S E R V I C E N O T E

**Agilent E4915A Crystal Impedance Meter**

**Serial Numbers:** JP1KD00101 / JP1KD00151

**Figure 1. AC Inlet Connector**

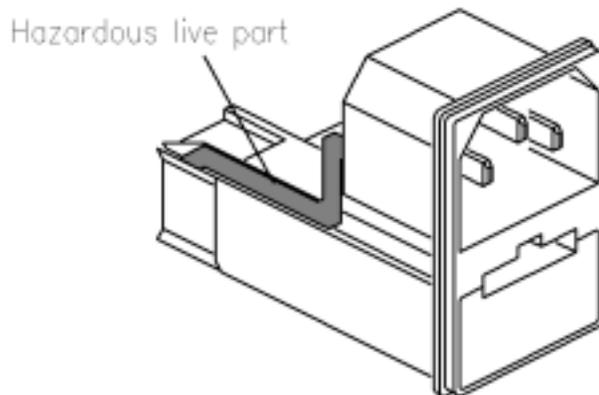
The AC inlet (P/N 1252-6951) has the potential to slip out of the instrument's rear panel slot if the AC power cord is forcefully pulled in a diagonal direction. When this happens, an exposed connection on the AC inlet module may touch the rear panel of the instrument and cause an electrical short if the AC power cord is still connected to the AC power outlet. See Figure 1.

In the worst case, there is also a possibility of an electric shock hazard to the user if the user completes a circuit between the instrument panel and another grounded connection while the AC power cord is still connected to the AC power outlet.

**Solution 1. AC Inlet Still Intact.**

- Remove the AC power cable from the AC power outlet and the product.
- Remove the top, bottom, and side covers.
- Seal the hot line terminal on the AC inlet with silicon paste (P/N 5183-4112).
- Reinforce the connection between the AC inlet and the rear panel with silicon paste.
- Perform Self Test to verify instrument operation.
